NIWA APARTMENTS

513 FIRST AVENUE NORTH
DESIGN REVIEW RECOMMENDATION
11.14.18 | MUP # 3029562-LU

Proposed Garage Ramp Section

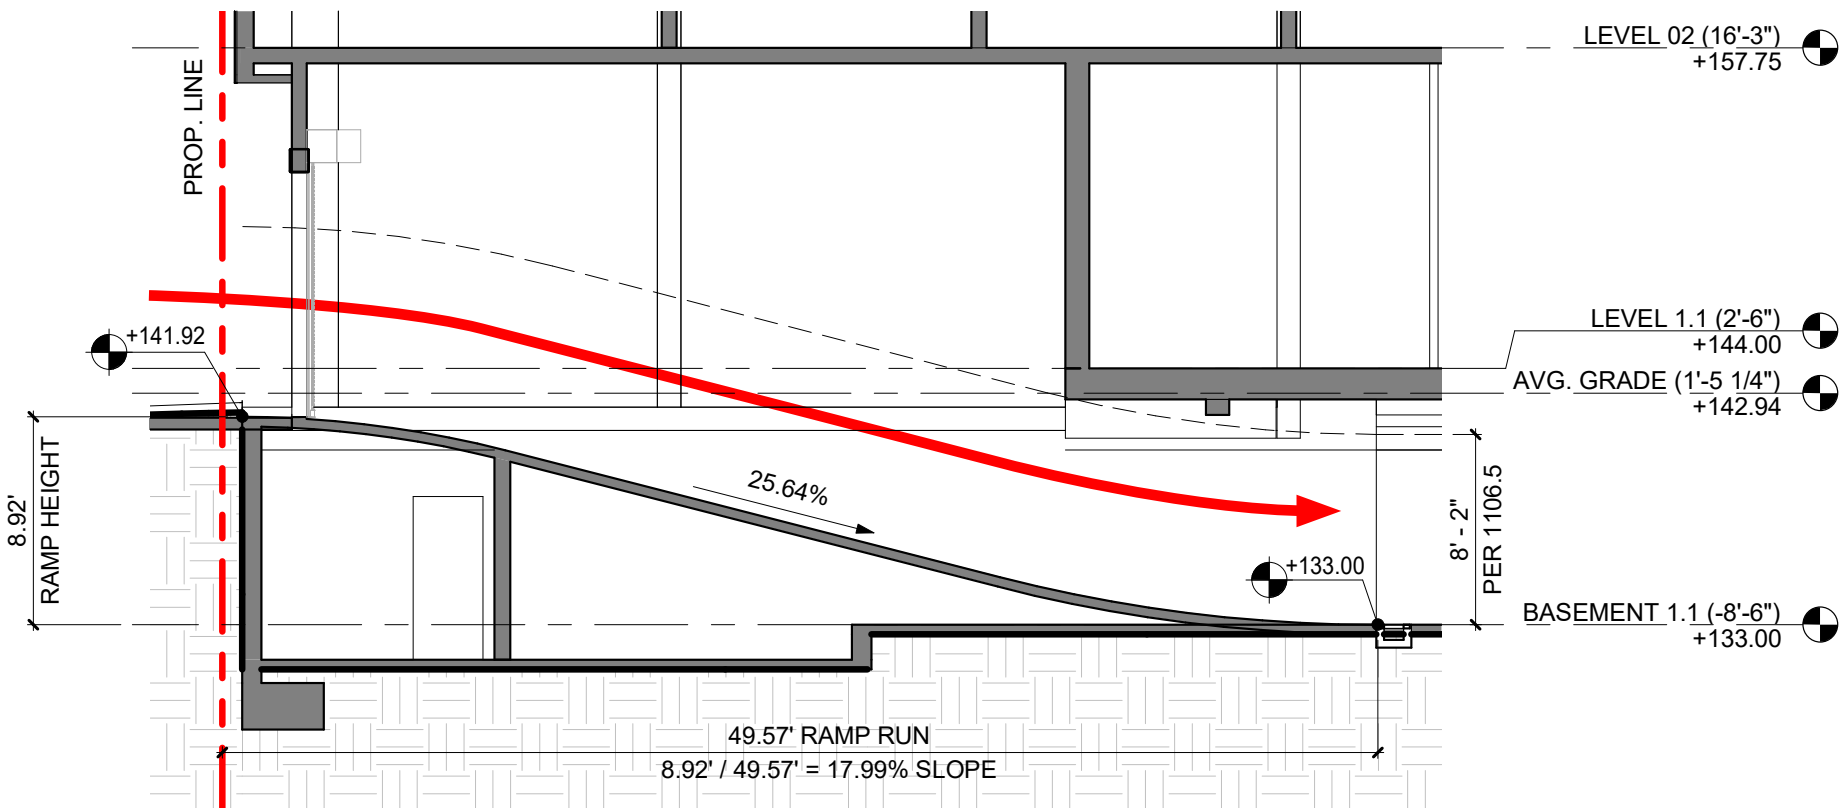
Request the 15% max driveway slope requirement be waived to allow for 18% average slope, with a maximum of 25.64%

The ramp location on the site was selected to maximize vehicle parking and allow for functional commercial and amenity space along the south property line. Due to the sloping topography and narrow width of the site a ramp at the required 15% grade would be infeasible as it would require significant floor area on the basement level. At the first floor, due to required overhead clearance to allow for accessible van access circulation and retail depth would be negatively impacted by a 15% slope ramp.

Since parking is being provided for resident convenience and not required by code we ask for a waiver of the 15% maximum slope requirement. A ramp with an average slope of 18% and maximum of 25.64% is the safest slope that will allow for better circulation and flow on the first floor of the building.
